**Minutes of the Meeting
July 16, 1998**

Fun Forest Phase II-IV
Interpac Development
Salmon House (Discovery Park)
Bus Shelter (Discovery Park)
Apprenticeship Training Center

071698.1 Project: **Fun Forest Phase II-IV**
 Phase: Phase II — Update
 Phase III— Design Development
 Phase IV— Design Development (Subcommittee: Batra, Sundberg)
 Previous Review: November 6, 1997
 Presenters: Dave Buchan, Seattle Center
 John Taylor, Callison Architecture
 Ahna Holder, Callison Architecture
 Time: 1 hr. (hourly)

Fun Forest site plan

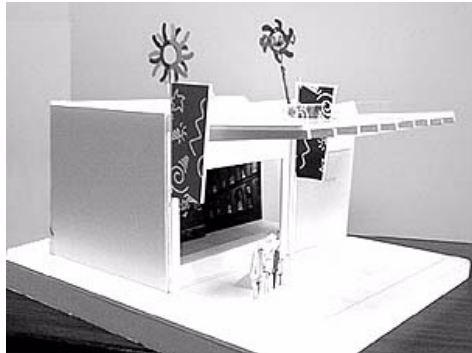
- Sundberg:** Personally, I find the existing "Joints" depressing and am encouraged by the direction of this project. I am also encouraged by the additional "Joint" at the south end, giving a sense of entry to the Fun Forest. The banners, strengthened by with the whirly-gigs, is a great way to link the Fun Forest to Kiddyland,

- Sundberg:** The Fun Forest generates a lot of revenue for the Seattle Center.
- Batra:** Is the skylight continuous along the row of "Joints"?
- Taylor:** Probably not. Due to budget constraints, it may become a row of individual skylights over each unit.

- Sundberg:** I encourage you to keep them as large as the budget allows. It is important to get as much light under the canopy as possible.
- Batra:** I like the design.

- Taylor:** Although they are treated as individual units, each "Joint" is subject to changing vendors and requires a certain level of consistency.
- Batra:** The metal doors may be an opportunity for some sort of graphics or artwork, especially since they are closed much of the time.

- Action:** The subcommittee appreciates the update on Phase II, the restaurant and maintenance shop, and recommends approval of Phases III and IV with the following comments and recommendations:

- the landscaping along the north edge of the Fun Forest adjacent to Harrison Street is a great improvement;
 - continue to work with the Experience Music Project in developing the paving joint at the east side of the Fun Forest;

- include sufficient seating within the Fun Forest area;
 - consider treating the "Joint" doors with graphics to enliven the space when doors are closed.

Site plan

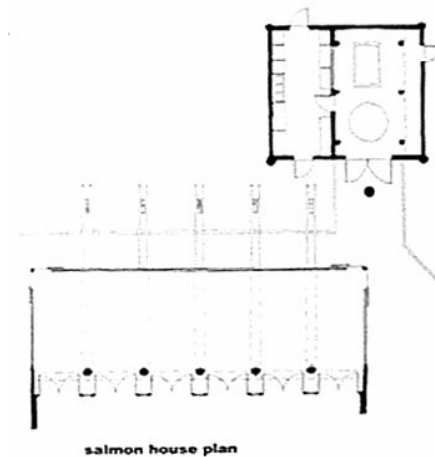
- Batra:** It appears that the circulation path between the Daybreak Star building structure and the Salmon House is very narrow.
- Darwish:** What is the method of cooking the salmon during a burn ban?

- Sanidad:** We use internal stoves rather open fires during burn bans.
- Hansmire:** The circulation from the preparation space to the new Dining room atrium is difficult and needs refinement. The corner entry into the Dining room also needs refinement in terms of in-and-out server use. Is there room on the site to move the building location slightly?

- Ransom:** Service access will be located on the east side of the Salmon House.
- Swift:** It is difficult to evaluate, without any contextual or site information, whether the Salmon House is situated in the best possible location or how the service access and trash receptacles will be integrated in the landscape.

- Hansmire:** A more advantageous siting of the Salmon House may be on the diagonal, facing the Dining room entrance.
- Swift:** I agree, it should be somehow related to the corner stairs and plaza as well as the dining room atrium.

- Action:** **The Commission supports the direction of the project as presented and makes the following comments and recommendations.**
- **provide adequate space for circulation between buildings with ADA and pedestrian friendly paving;**

- **reevaluate the Salmon House siting in relation to the Daybreak Star building and the surrounding landscape, while fully addressing service requirements for refuse collection;**

- **develop a comprehensive site plan showing relationships with existing and proposed buildings, access, and circulation;**
 - **the Commission also encourages the addition of a restroom facility within the Salmon House.**

East elevation & perspective

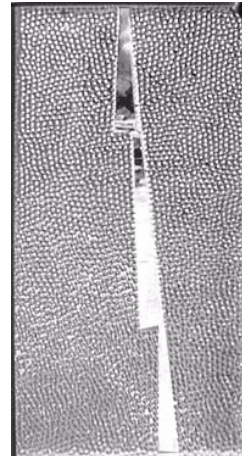
- Batra:** Why is the outdoor training yard enclosed by a fence?
- Floor:** It is fenced in currently to delineate the training area from parking areas. We are only replacing the existing fence and adding a short concrete retaining wall.

- Sundberg:** I think the art concept is terrific.
- Marioni:** The pattern of the glass is not yet designed. The glass artwork will be sealed behind thermal pane windows for added efficiency and noise reduction.

- Batra:** Do you work only with glass?
- Marioni:** I work a lot with glass and metal, but I also design furniture and do torazzo work.
- Darwish:** I like the glass artwork. I wonder if the two buildings and training yards could be more tied together. Perhaps removing the canopies and using the training yard retaining wall as a curb to connect the outdoor spaces would tie them together.

- Floor:** The users would probably object to additional curbs or retaining walls.
- Darwish:** Perhaps just changing the concrete canopy to steel would tie the two buildings together visually.

- Hansmire:** A metal canopy might better unify the two buildings, but I wonder if it is a viable recommendation at this point in the design. The current design doesn't bother me. A concrete canopy will have better protection against the rain than a metal one.

- Read:** It looks like the thermal pane glass over the artwork has a green tint.
- Floor:** It will be clear. We had hoped to use some tinted glass, but it is not in the budget and would probably detract from the artwork.

- Action:** **The subcommittee appreciates the design team's attention to previous comments and recommends approval of the project as presented. The subcommittee is enthusiastic about the direction of the glass artwork.**
